REQUEST

Current Zoning: IC-1 (Institutional Campus-1), CG (General Commercial), N1-A (Neighborhood 1-A)
Proposed Zoning: N2-B(CD) (Neighborhood 2-B, Conditional)

The petition proposes a residential community of up to 575 multi family attached dwelling units on vacant land.

STAFF RECOMMENDATION

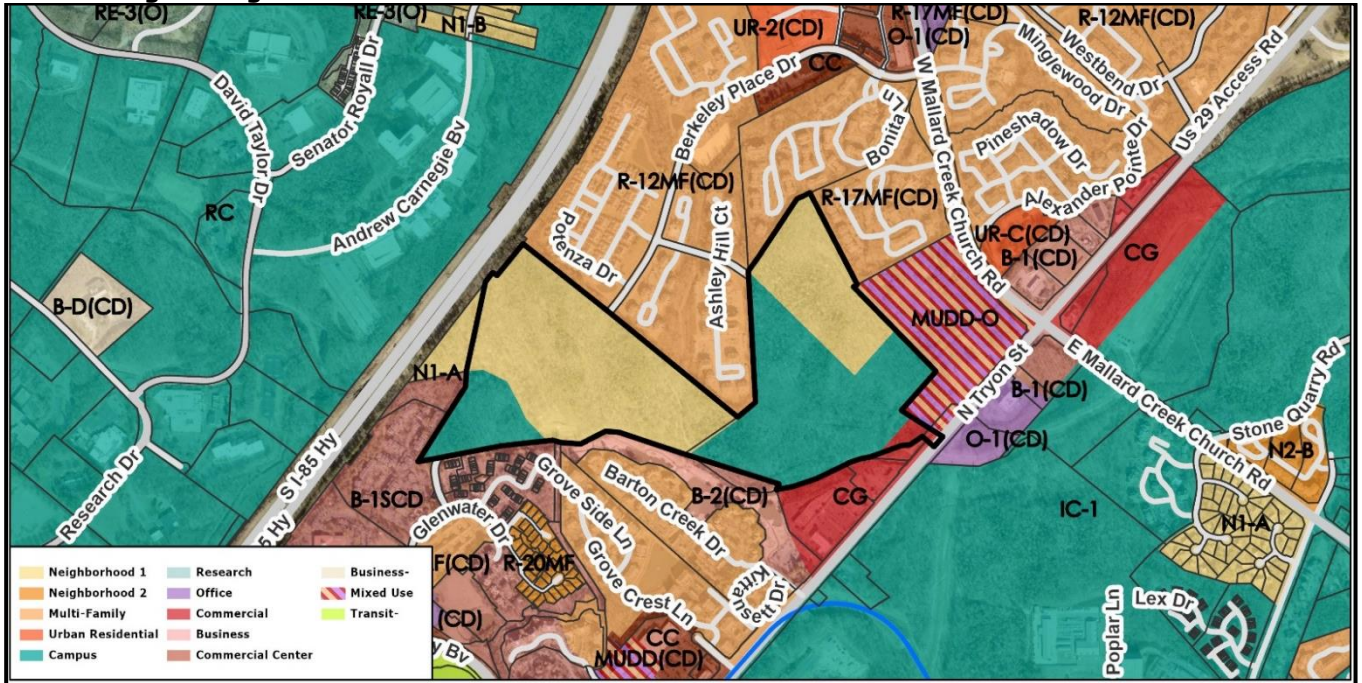
• Proposed Request Details

The site plan accompanying this petition contains the following provisions:

- Allows up to 575 multifamily attached dwelling units.
- Provides an 8-foot-wide planting strip and an 8-foot-wide sidewalk on both sides of all internal streets.

- Vehicular access to the site is provided by connections to Berkely Place Drive, Salerno Drive, and Emerald Cove Drive.
- Dedicates right of way on the westernmost street over the stream to accommodate the potential future extension of this public street over the stream to connect the southern and northern portions of this public street.
